**REMEDIATION SYSTEM EVALUATION**

**OCONOMOWOC ELECTROPLATING SUPERFUND SITE**  
**ASHIPPUN, WISCONSIN**

Report of the Remediation System Evaluation,  
Site Visit Conducted at the Oconomowoc Site  
14-15 March, 2000

Final Report Submitted To Region 5  
August, 2000  
(Reformatted, January 24, 2001)

Figure 4-1. Observed concentrations, MW-05D

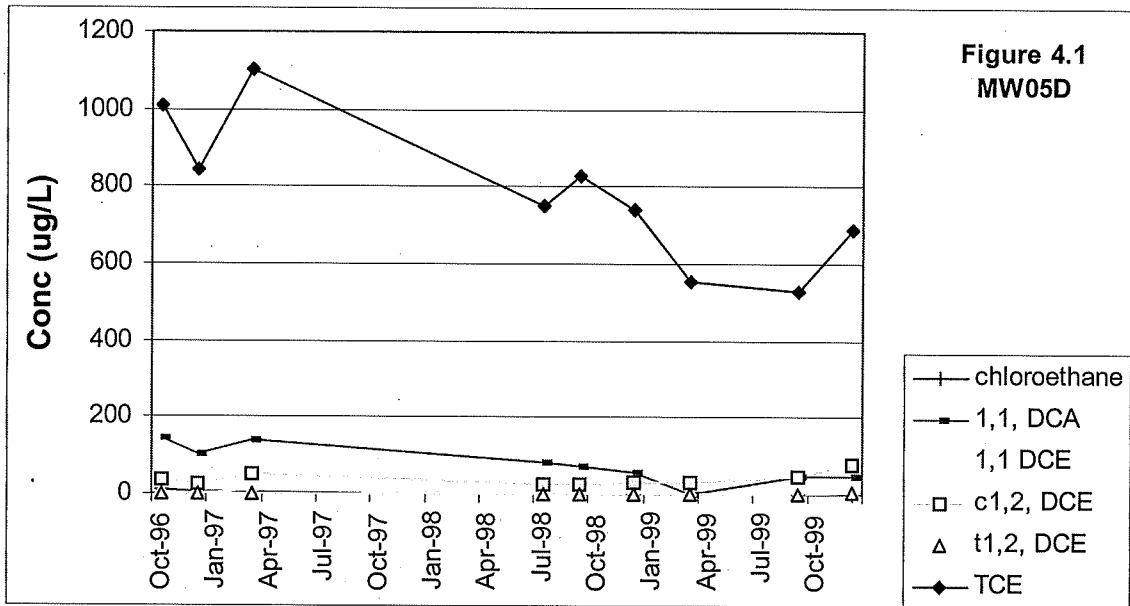
Ground water samples are currently obtained from monitoring wells MW02D, MW05D, MW06S, MW12B, MW12D, MW14D, MW15D, and MW16D. If not dry, samples are also obtained from MW03S and MW05S. Although hydropunch sampling done during the pre-design investigation indicated the limits of the plume, the plume is not well defined by the current monitoring system. The primary concern appears to be chlorinated organics in ground water. The extent of the organics plume is not clearly defined east of EW-3, MW05D, and EW-5, and is also not clearly defined west of MW15D (within a residential neighborhood where wells are used for water supply). Levels of TCE in MW15D, which is screened within the shallow aquifer, have consistently measured near 30 ug/L in this residential area. Residential wells are screened in the deeper bedrock aquifer, and detections of TCE of approximately 0.5 ug/l at these residential wells were mentioned during the site visit. Monitoring well MW05D has consistently shown levels of a number of organics, particularly TCE, above the PALs. Although concentrations in MW15D have been quite stable, there is evidence for decreasing concentrations of TCE and 1,1 dichloroethane in MW05D as shown in Figure 4-1.
